V2500-A5/D5 SERIES PROPULSION SYSTEM SERVICE BULLETIN

This document transmits the Revision 1 of Service Bulletin V2500-ENG-72-0279.

V2500-ENG-72-0279

# <u>ENGINE - LP COMPRESSOR - TO INTRODUCE A SMALL DIAMETER PIN ON THE LPC BLEED VALVE RING</u>

Booster Stage Bleed Valve and Actuating Mechanism Fig.2

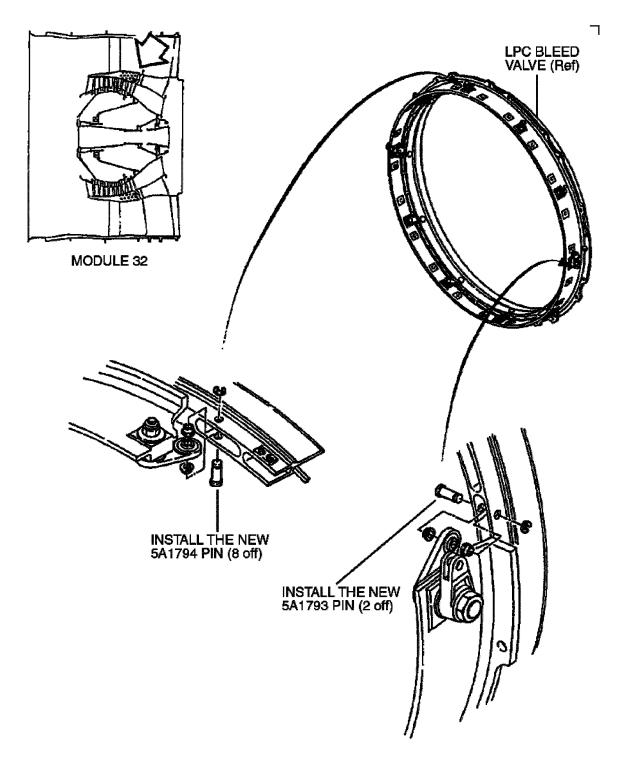
- R A. Rework Instructions
- R There are no rework instructions necessary to accomplish this Service Bulletin.
- R B. Assembly Instructions
- R (1) Install the new 5A1793, two pins and the new 5A1794, eight pins into the LPC Bleed Valve Ring by the approved procedures of Reference (2), Chapter/Section 72-32-70, ASSEMBLY-01 CONFIG-2 (For V2500-A5) and Chapter/Section 72-32-70, ASSEMBLY-01 (For V2500-D5). (Refer to Figure 2)
- R C. Recording Instructions
- R A record of accomplishment is required.
